intel® Technical Advisory

TA-0337-1

SR2050 Installation Procedure Update for the STL2 PCI Flex Riser

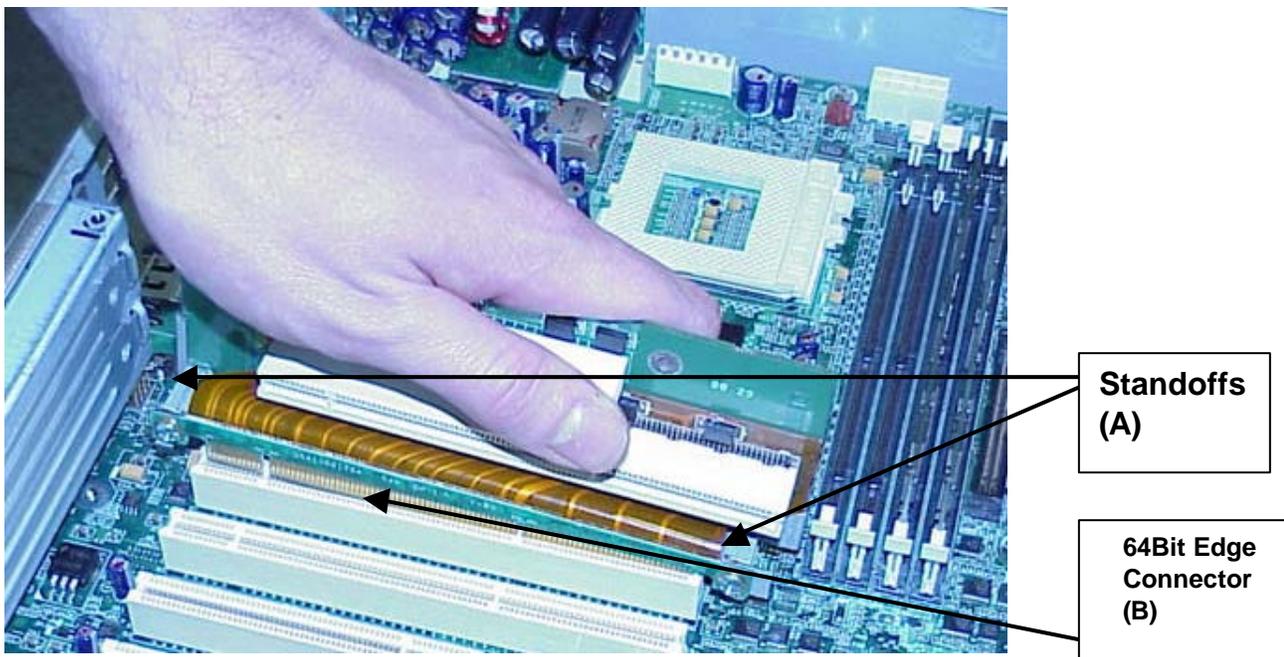
Intel has determined that it may be difficult to install the STL2 flex PCI riser (A32819-30x) into the STL2 baseboard using the steps provides in the SR2050 Product Guide. To resolve this issue, Intel recommends the steps listed below be used to install the Riser.

- Do not press on the flex circuit - stress may induce cracking or tearing, leading to failures.
- Do not press on the riser's 64bit PCI connector (B) during installation. Stress could weaken the integrity of the components, possibly resulting in failures.
- Use standard ESD precautions while completing the installation (see page 21 of SR2050 Product Guide for details).

- c. Apply downward pressure to the flex riser to seat it into the baseboard. Carefully rock the riser to seat it properly into the PCI slot. In some cases it may be necessary to press on the standoffs (A) to fully seat the card into the baseboard.
Use caution so that pressure is not applied to the flex circuit material or the 64bit edge connector (B).

- 1) Install flex riser into baseboard.
 - a. Grasp the top of the riser with one hand (see Picture below).
 - b. Align the flex riser with PCI slots 1 and 2 of the STL2 baseboard (see Figure 15, page 33 of the Product Guide) and insert one end of the 64bit edge connector into the PCI slot.

- 2) Attach mounting bracket to riser card with 2 screws.
 - a. Reposition the riser mounting bracket to its original position (see Figure 5 page 22).
 - b. Attach the riser to the mounting bracket with 2 screws.

- c. Attach the assembled riser with mounting bracket to the chassis with 2 screws.
